LARAMIE COUNTY PLANNING & DEVELOPMENT DEPARTMENT

MEMORANDUM

TITLE: PUBLIC HEARING regarding a review and recommendation of the Preliminary Development Plan for Roundtop Ranch, located in the W1/2 Section 10, T.14N., R.67W., of the 6th PM, Laramie County, WY.

ROUNDTOP RANCH Preliminary Development Plan

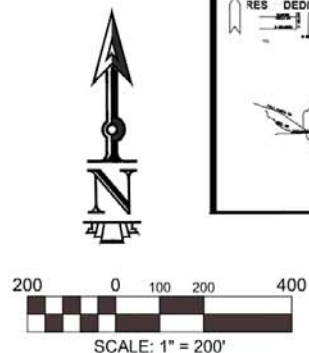
5. Per the Environment & Services Impact Report, Roundtop Road is identified as a “Major Collector” and a “Rural Collector” - “Rural” seems to conflict with “Major” when describing the collector road usage-- is this description accurate??

Trip generation for Roundtop Road will be provided with Final Plat Traffic Study; the actual ADT adjacent to the project in 2016 was 140. The City/County/MPO *Functional Classification Concurrence* designates Roundtop Road as a (future) major collector. The road is constructed as a “Rural Collector - Low Volume” pursuant to LCLUR§ 3-5-109 (Fig. 12).
